**Subject:** 600 E Rand Road- Southpoint PUD Amendment

**PC #:** 21- 018

**PLAN COMMISSION PC #21-018**  
**Southpoint Outlot PUD Amendment**  
**600 W Rand Rd**  
**Round 2**

# Planning & Community Development Dept. Review

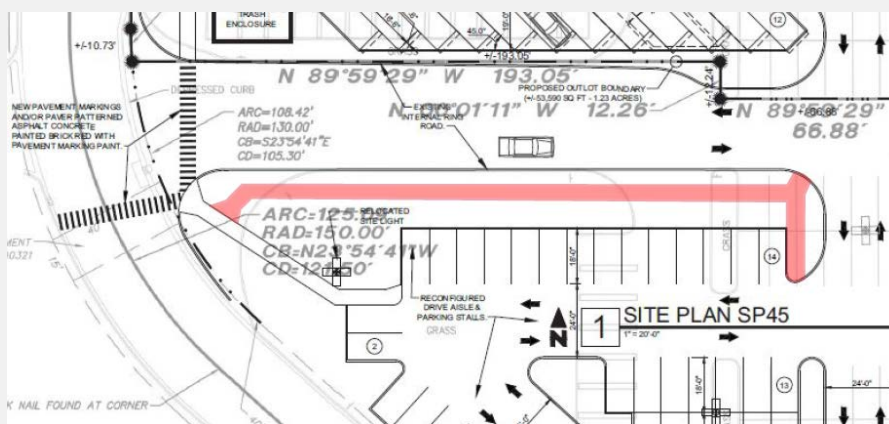
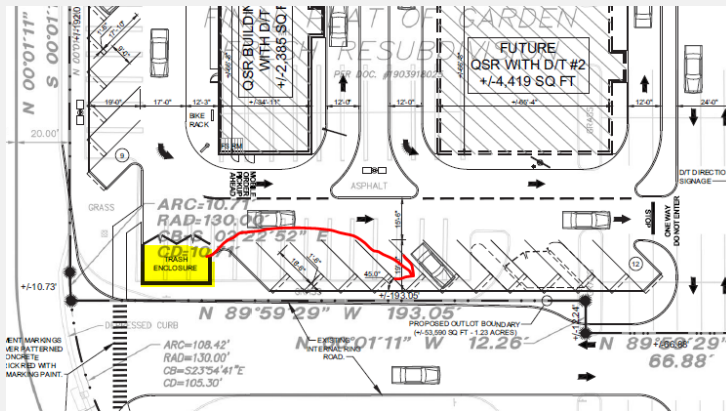
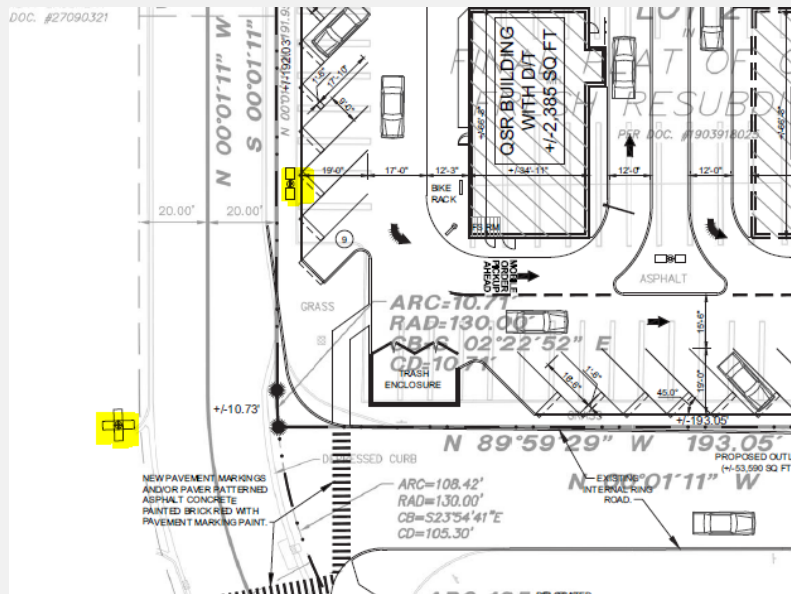
42. The response to comment #21 is noted. An additional walkway should be provided, as shown approximately below, for enhanced pedestrian connectivity. Crosswalks shall be decorate/stamped concrete; pavement paint only will not be acceptable.

43. The response to comment #24 is noted. The dumpster enclosure must be moved to a more central location to allow use by both tenants (see below) and shall be expanded in size to accommodate for the dumpsters of the future building. It is recommended that the enclosure also include space for the transformer.
